Adamstown Boulevard - Phase I

RFI Response - SDZ22A/0007  
September 2022

## RFI Item 3.b

Job No.	23A2A	Drawn By	KFR
Dwg No.	L1-902-4	Checked By	JM
Scale	1:20 @A1	Date	AUG.2022

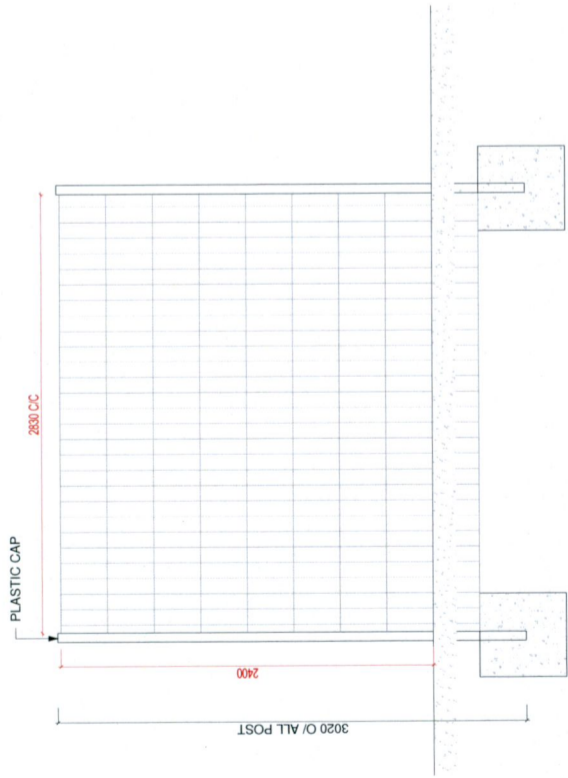
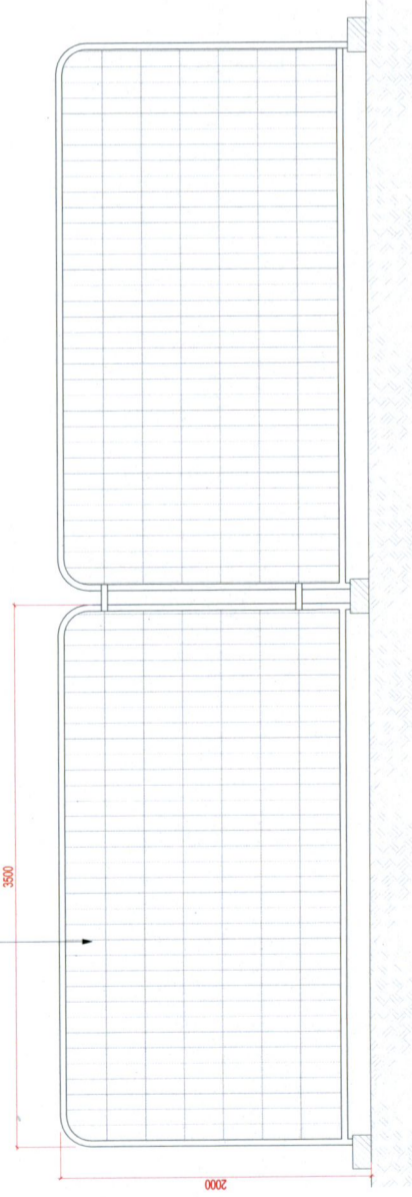
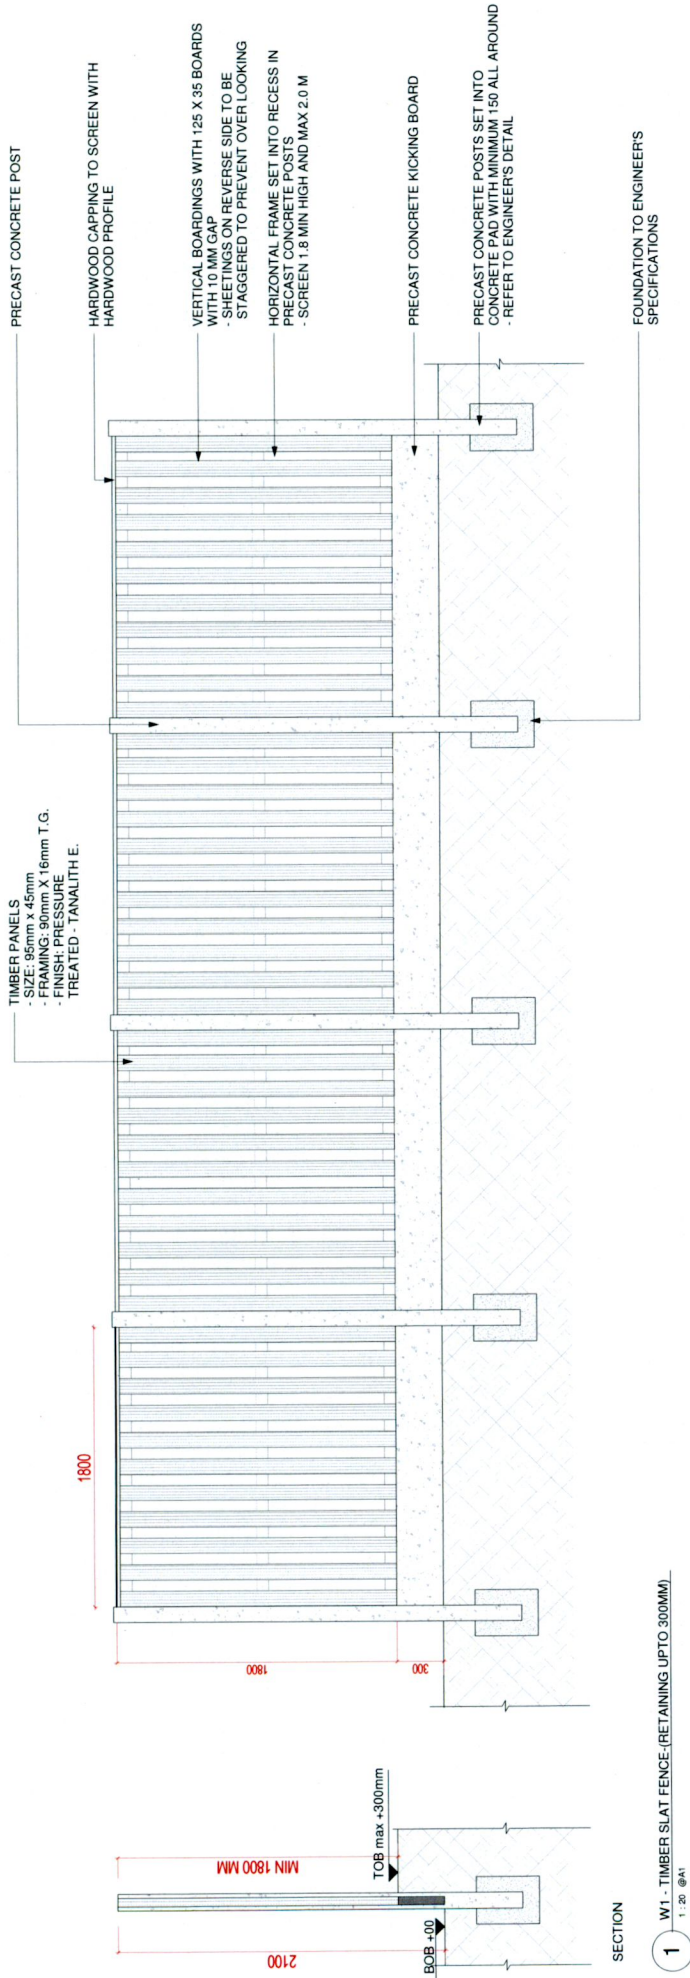
#### 3.b The applicant is requested to provide revised boundary treatment details / landscaping details for the boundary of the properties close to the hedgerow to the west

Refer to L1-102 – *Temporary Boundary Conditions* plan indicates that a block and mesh fence will align 1-2m from the edge of the root protection zone for the existing hedgerow to protect the biodiversity during the construction phase. The existing oak tree located at the pocket park will also be retained and protected with paladin fence. Refer to details L1-902-4

# RFI Item 6 - Open Space Plan

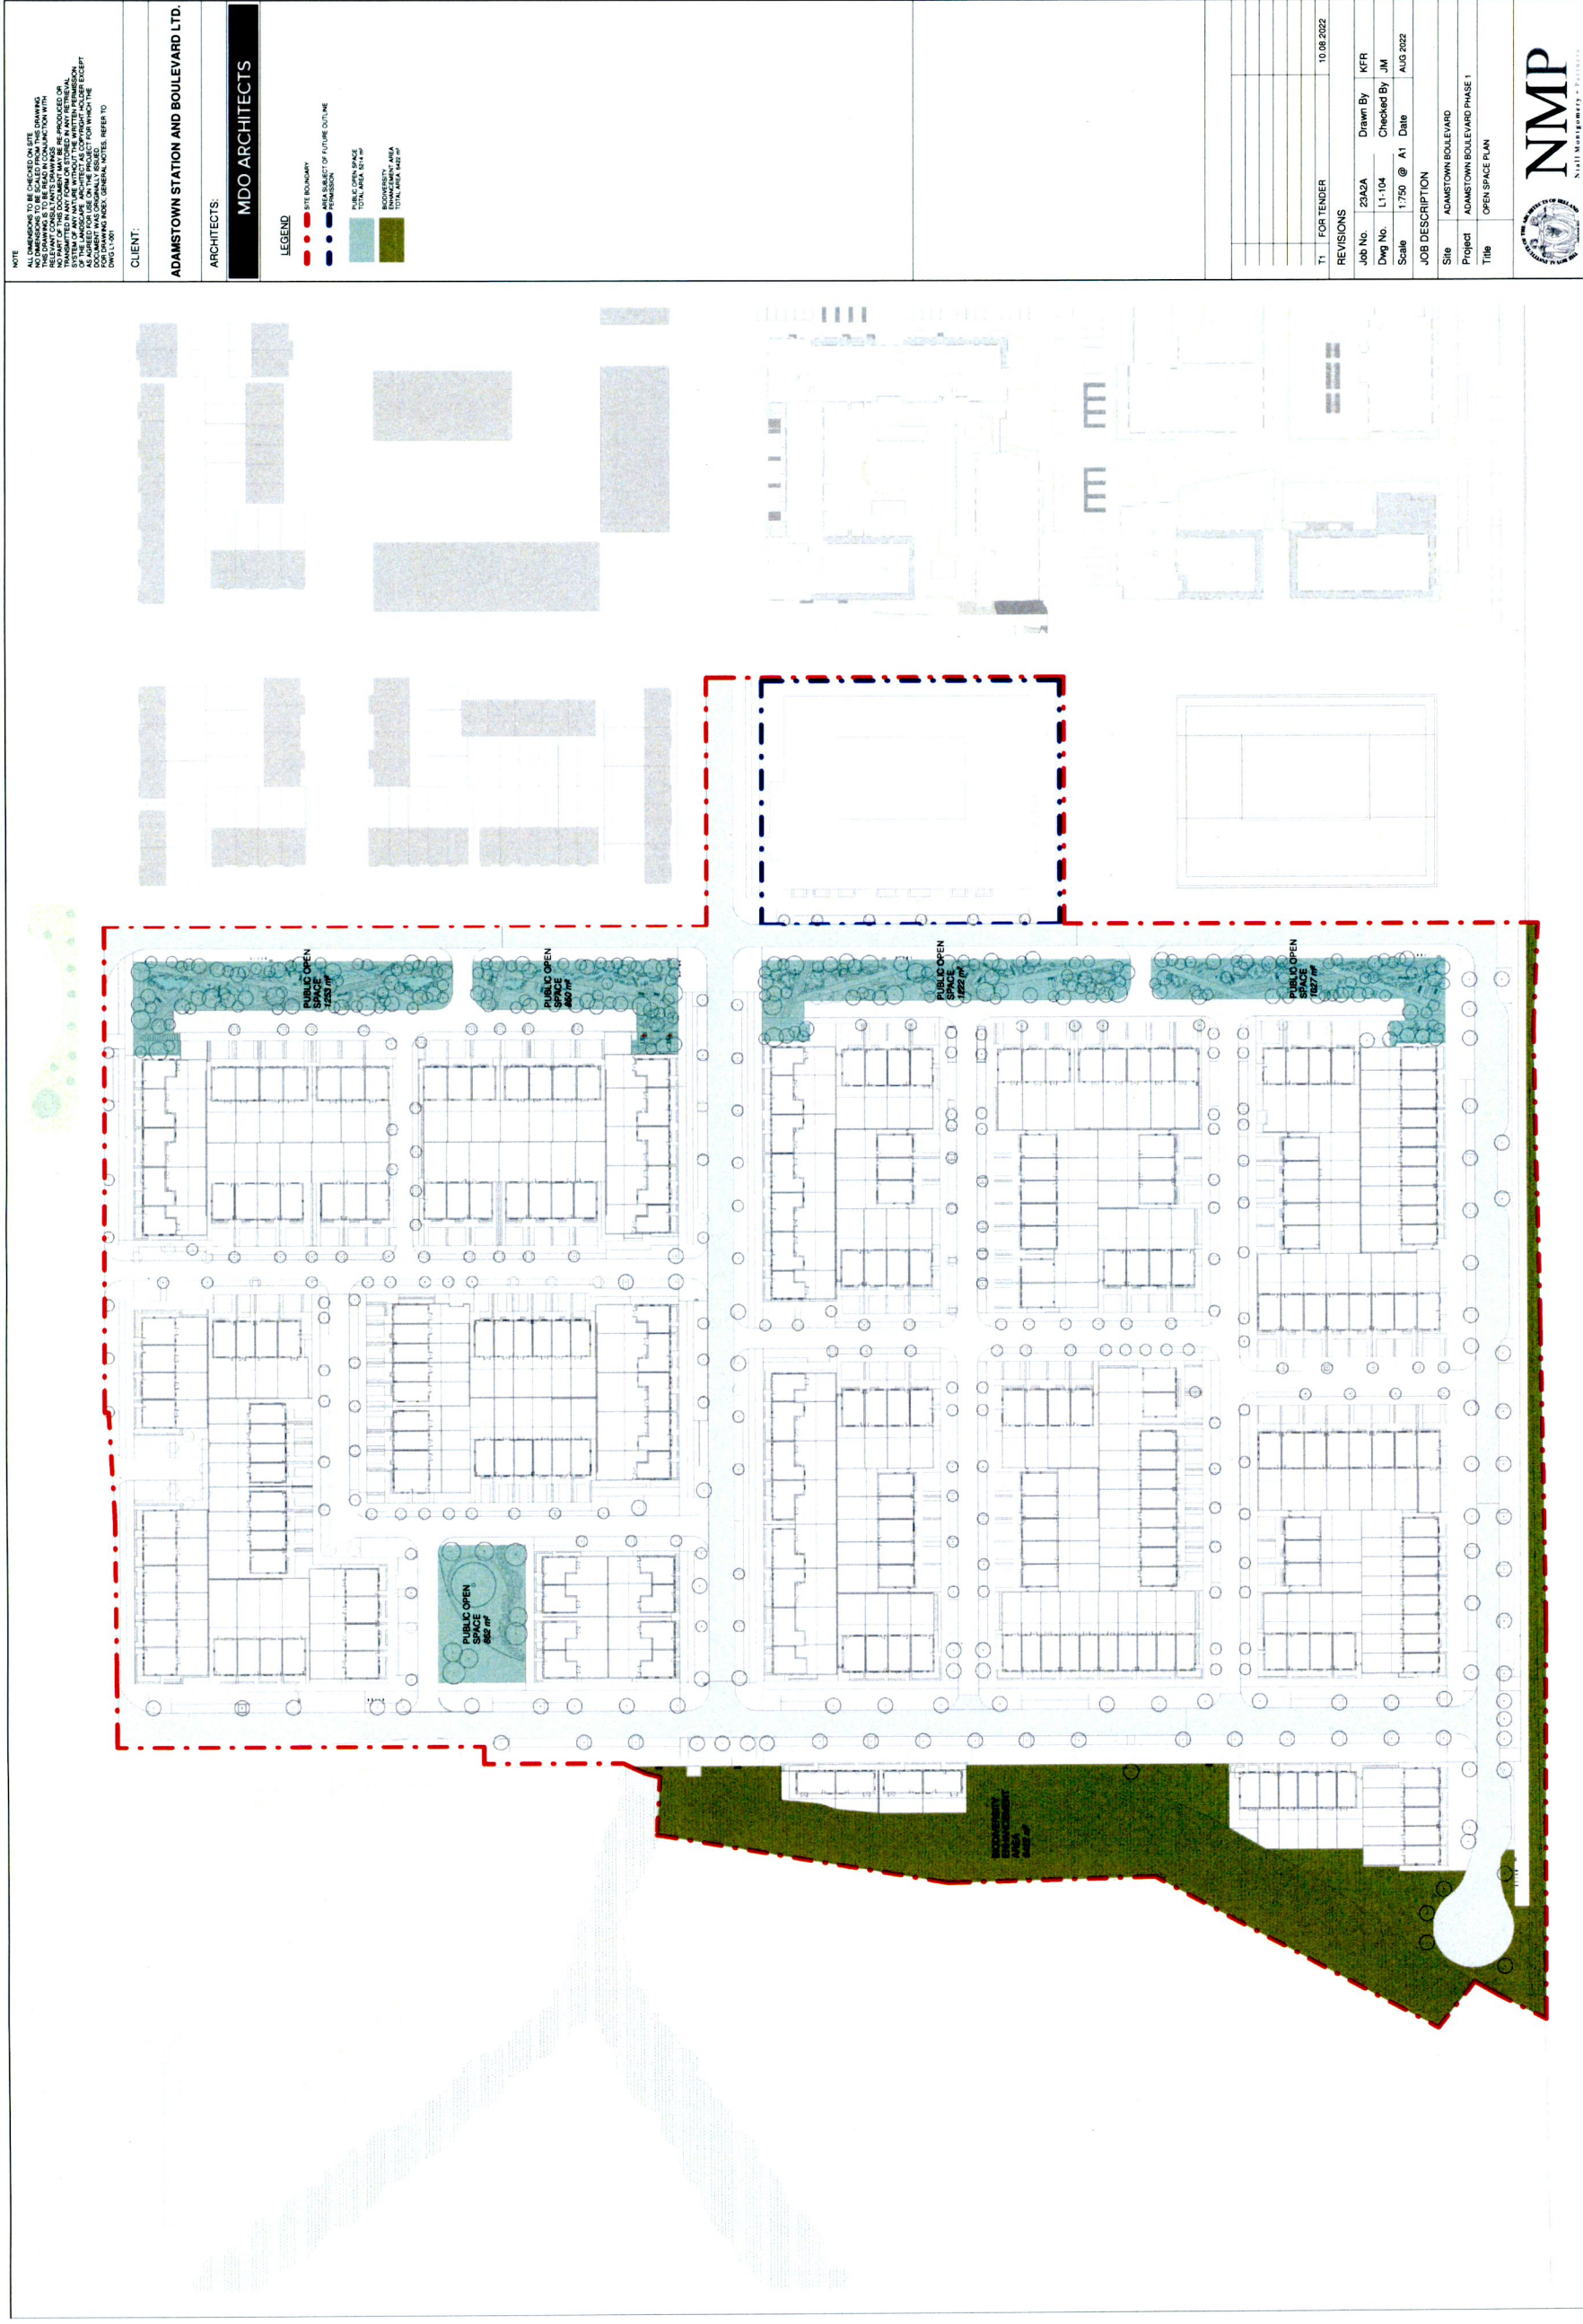
6. While it is noted that the applicant has indicated that the proposed public open space provision would significantly exceed the minimum quantum required by the Planning Scheme, for this tile, concerns are maintained that areas to the south (adjacent to Station Road) and to the west of the site (areas which contain the existing hedge row) may not be usable public open space. The applicant is therefore requested to provide further information in relation to the usability of these spaces.

The ecological intent was to have a positive impact on biodiversity by creating habitats with native species. The design intent for the western hedgerow mitigation area was not to create more park space or 'usable' space. The overall application reaches the requirement for public open space so we do not need to make this area usable. Moreover, the buffer zones / filling out the hedgerow was advised by the project ecologist.

Please refer to drawing L1-104 - *Open Space Plan* for further breakdown of public open space and biodiversity enhancement areas.

The solution of the hedgerow mitigation as a biodiversity enhancement area has been discussed and agreed upon by South Dublin City Council.

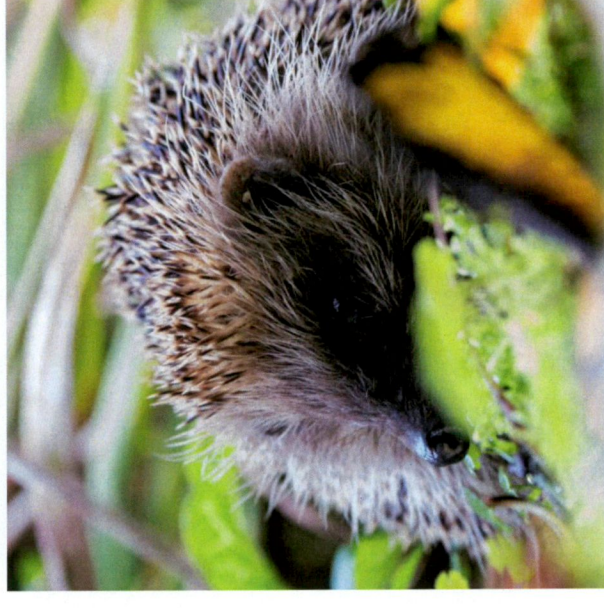
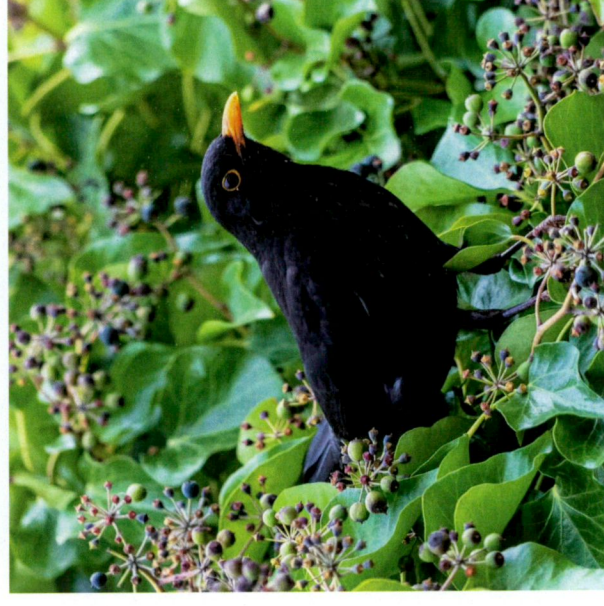
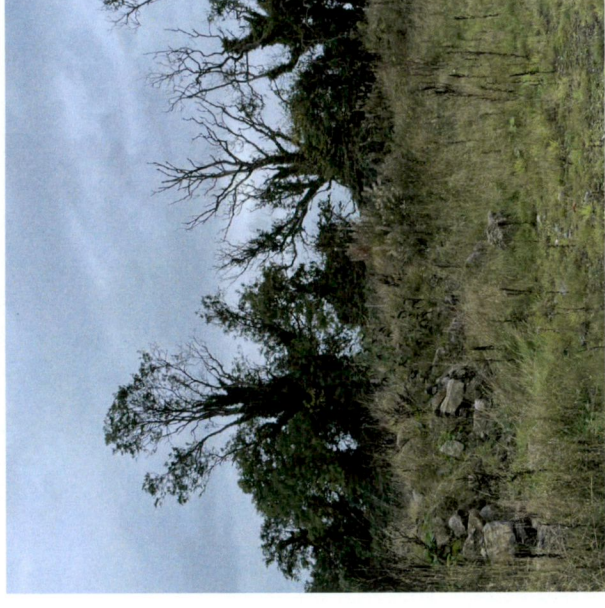
A statement outlining recommended acoustic control measures that should be incorporated into the design and construction of the proposed houses and/or site to ensure the use will not create adverse noise impacts on the occupiers. This should include parameters for walls, glazing, doors and ventilation for the proposed development.

Per the acoustics report by iAcoustics, the primary noise sources impacting the development is caused by road traffic and rail noise from the railways line running East-West to the south of the site. In order to mitigate noise exposure in private gardens due to train passing, we recommend a 2.4m solid block wall to be added at critical locations. Increasing the garden walls from 1.8m standard to the 2.4 block wall creates a noise barrier to rear gardens near the railway line.

In reference to RFI item no. 3b, the acoustic wall measure needs to be balanced with the careful protection of the hedgerow root protection area. Please refer to drawing no. L1-101 - *Permanent Boundary Conditions* for the proposed location of the block garden walls (at 2.4m and 1.8m) and timber slat fence (1.8m). Details for the block garden wall, please refer to architectural drawing A-45011.
